DRAINAGE LETTER REPORT

NOR'WOOD BIBLE CHURCH LOT 38, SADDLEHORN RANCH FILING NO. 3

October 13, 2023
Revised January 15, 2024
Revised May 9, 2024
Revised June 28, 2024

**JPS Project No. 042303
PCD Filing No. PPR2346**

SADDLEHORN RANCH - FILING 3
PROPOSED DRAINAGE MAP
JOB NO. 25142.05
5/15/24
SHEET 1 OF 4

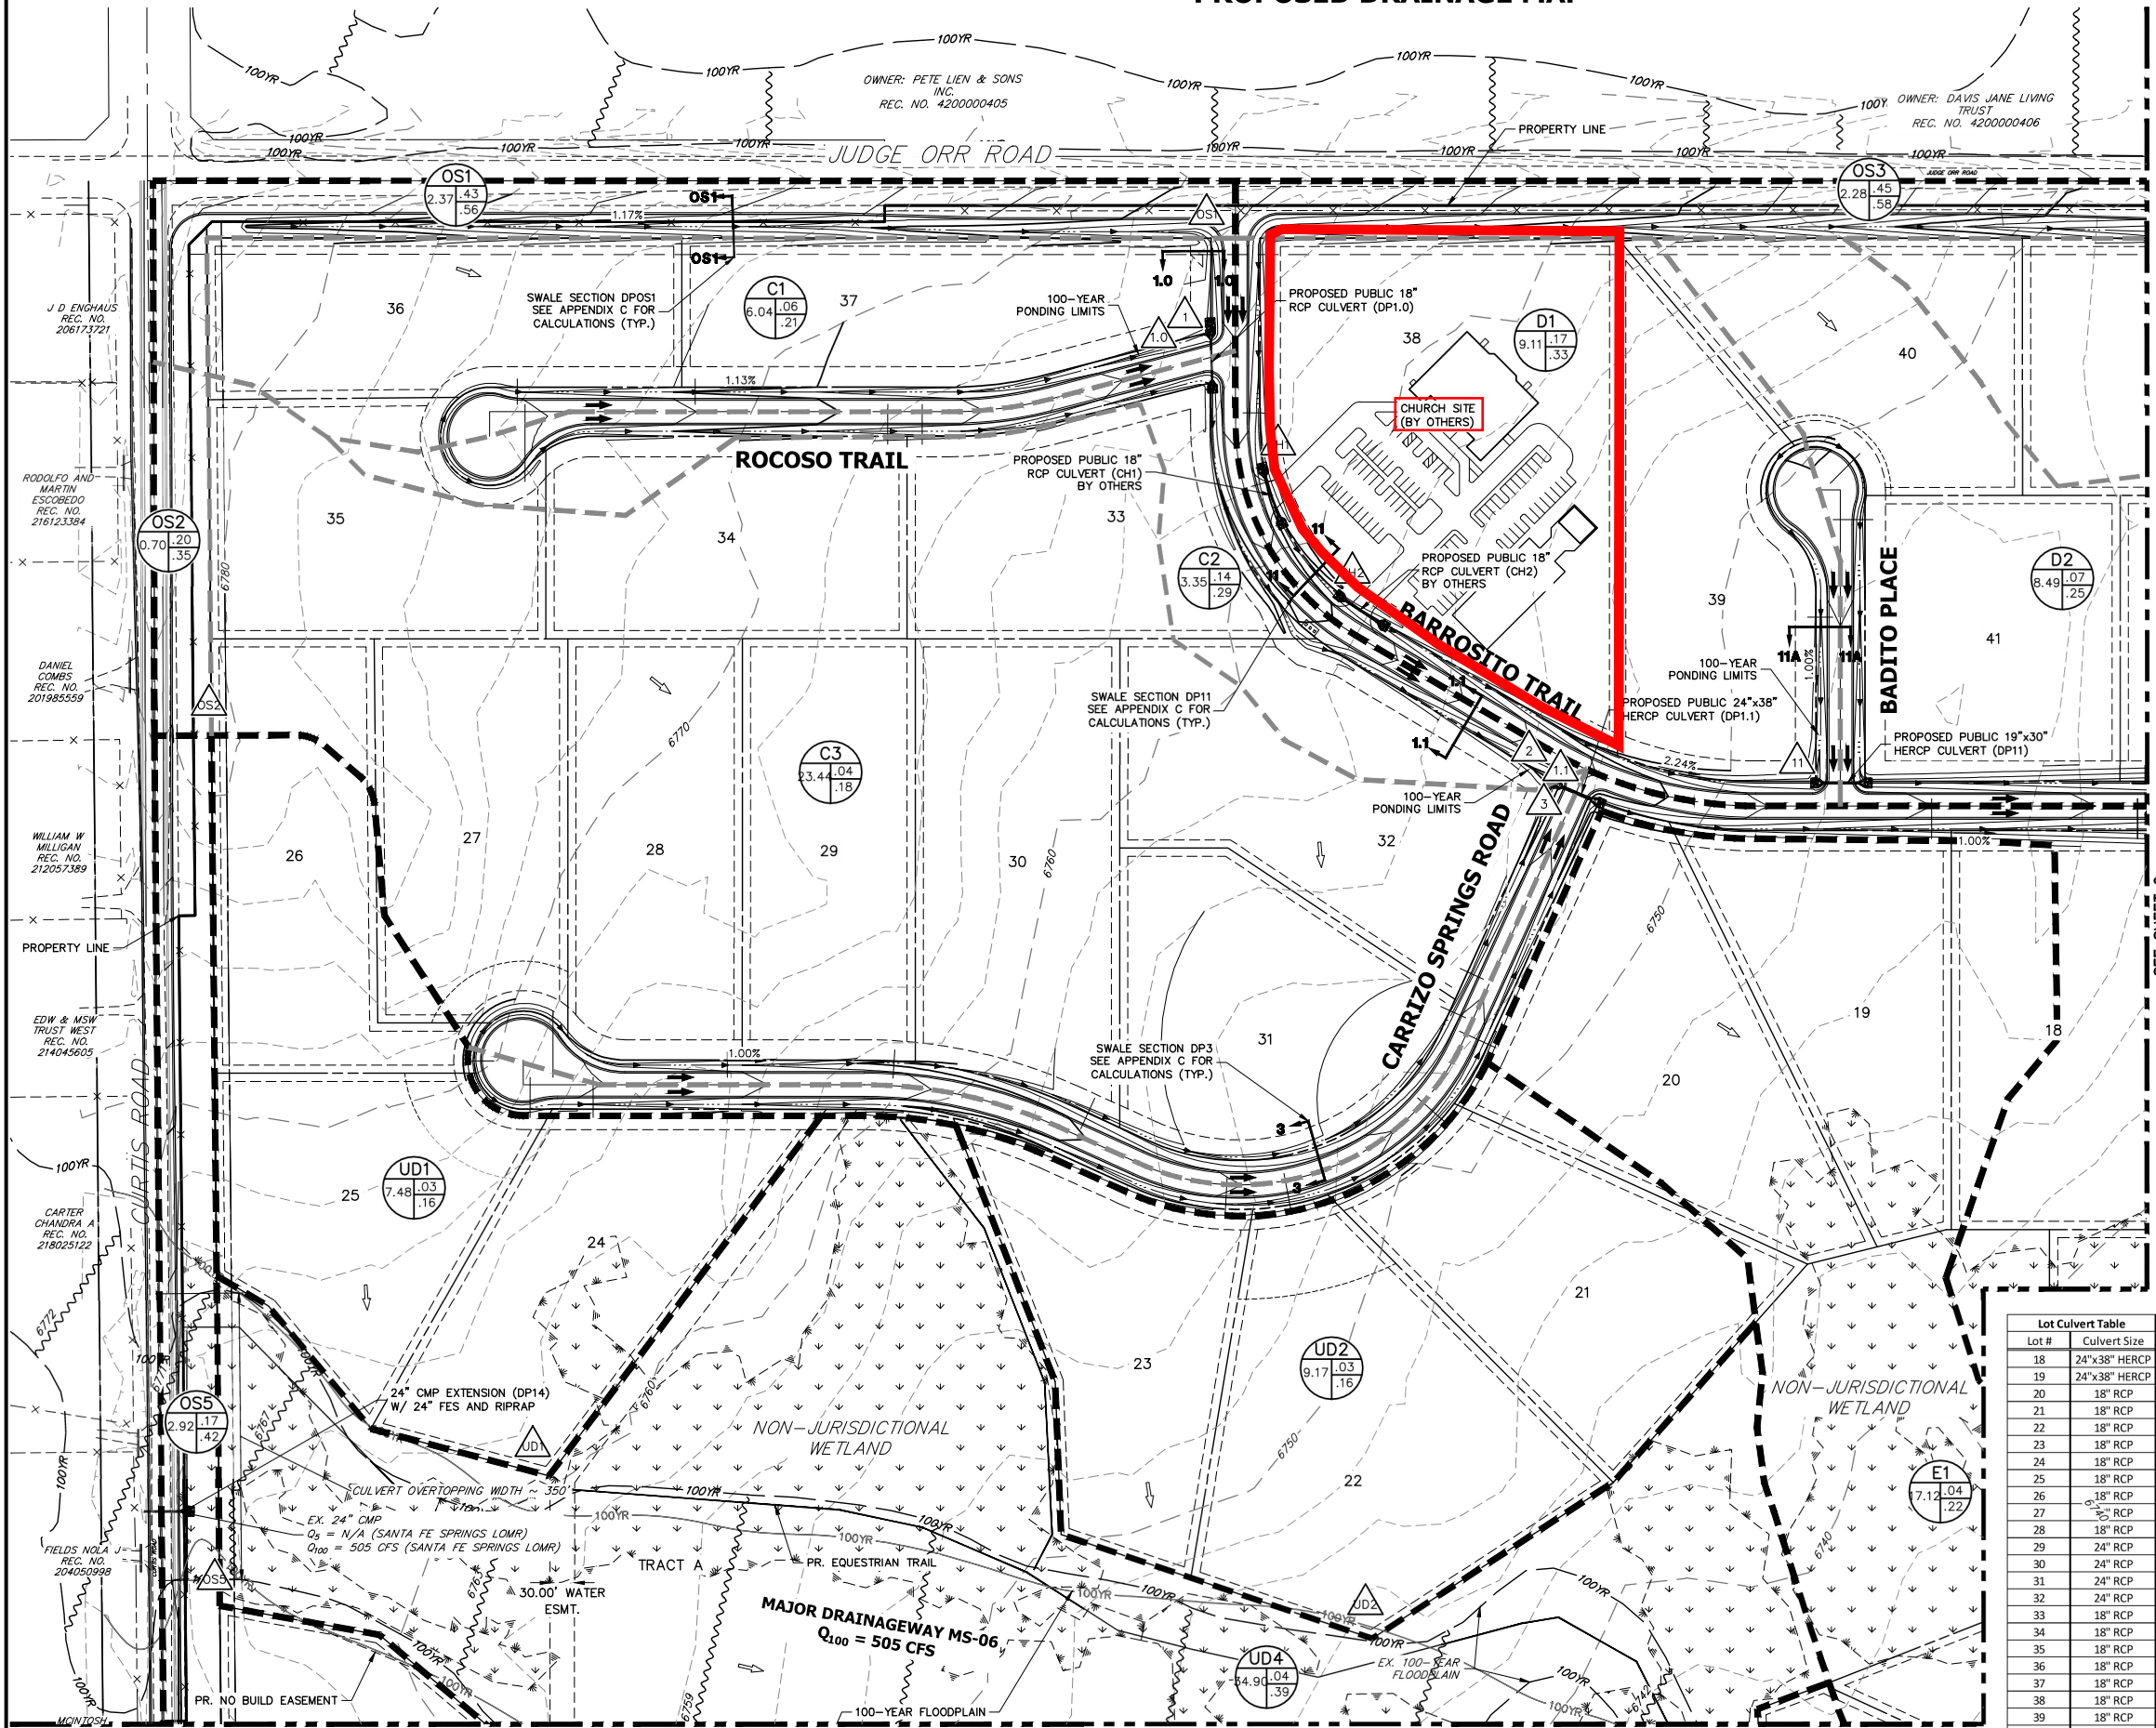
Review C3: Where did calculations come from? It appears that these calculations were not included in the SF234. Please update the excerpt once the SF234 gets approved.
 Review C4: Unresolved.

Please revise this number to match the calculation approved in SF234

Review C1: Need to include portion of spreadsheets which calculate flows.

Review C2: Unresolved
 Review C3: Unresolved
 Review C4: Unresolved
